Re: Truss Repairs - JCOP - Jonesboro

Approved as Change Order #1

Re: Truss Repairs - JCOP - Jonesboro

WTG/mlm c:\winword\letters4\o103.doc Justice Complex Trusses March 6, 2006 Page 2

## TYPICAL TRUSS LOOKING SOUTH EXISTING WOOD TRUSS

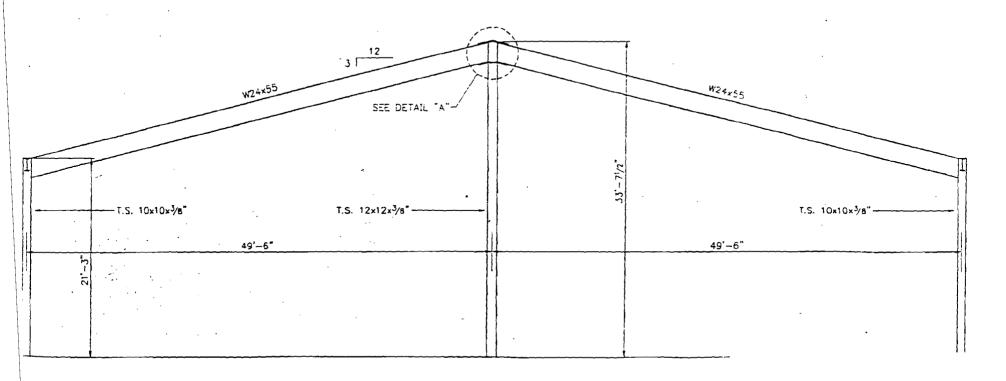
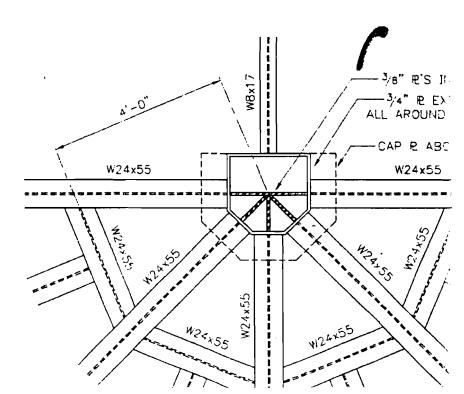
In response to our phone conversation of last week, we are revising our original price for the additional trass repairs. As per the phone conversation, we propose to use two 2 x 6, #1 YP members with 3/4" CD plywood sandwiched between to replace the numbered pieces to be repaired and recommend that the epoxy injection system be used on the lettered pieces to be repaired. The fist of replaced or repaired pieces is as follows:

- 1. Truss 1 No. 3
- 2. Truss 3 No. 2, 4, 17, 19, F
- 3. Truss 4 No. 2, 10, C, D
- 4. Truss 5 No. 20
- 5. Truss 6 No. 17
- 6. Truss 7 No. 3, B, G

I received a letter from Kermit B. Buck & Son, Inc. concerning the truss repairs that they made to the above referenced project. They feel that more repairs should be made in several more locations through-out the existing building. Following is a list of the wood members that they feel should receive the truss repair process:

- 1. Truss 1 No. 8
- 2. Truss 3 No. 2, 4, 17, 19, F
- 3. Truss 4 No. 2, 10, C, D
- 4. Truss 5 No. 20
- 5. Truss 6 No. 17
- 6. Truss 7 No. 3, B, G
